Model: General

Ref. No. : FF-T01-F-000025-01

Date : December 18, 2001

Subject: Modification to the Procedure of Adjusting the Left/Right Image Margin in the Cassette

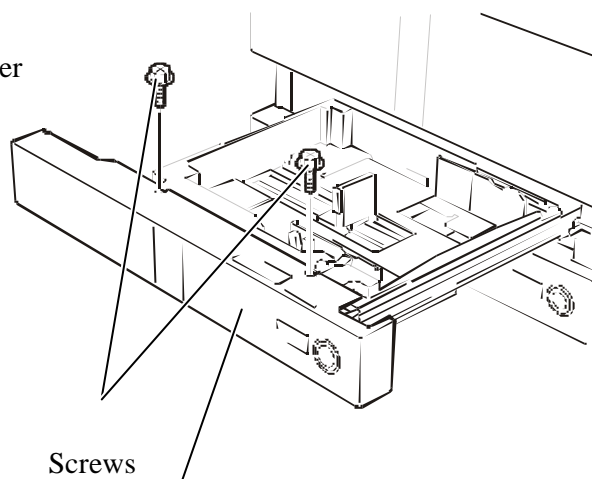
Reason: To improve productivity, the side registration adjustment screws (FB3-9358) in the cassette have been abolished. Accordingly, the procedure of adjusting the left/right image margin in the cassette is changed.

Detail: Conventionally, the side registration adjustment screws were used to adjust the left/right image margin. The adjustment procedure is changed as follows. (For the conventional adjustment procedure, refer to the Service Manual.)

1. Draw out the cassette.

Remove two screws from the cassette front cover and remove the cover.

<Note> The shape of the cassette front cover varies by the model.

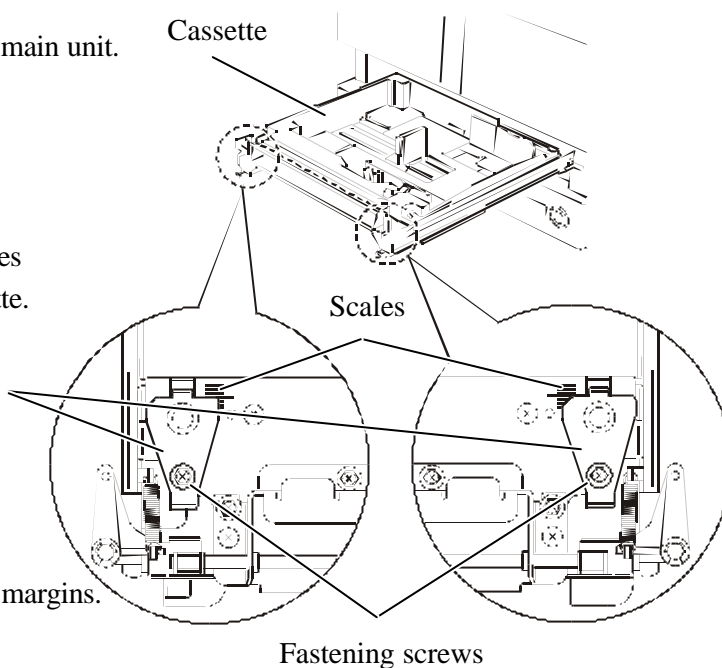
3. Loosen the fastening screws
on the side registration adjustment plates
on the left and right sides of the cassette.

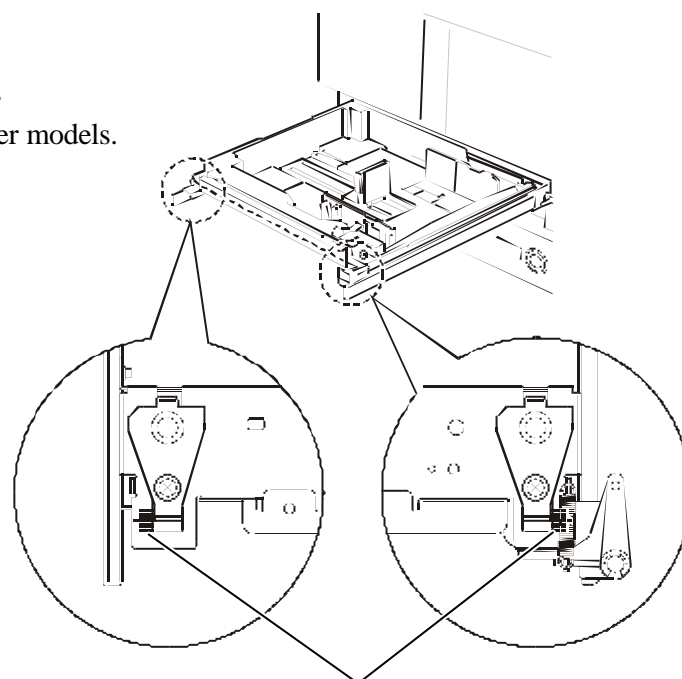
4. Watch the scales and slide the side
registration adjustment plates to adjust margins.

<Note> The scales on iR5000/6000 series
are located at different positions from other models.
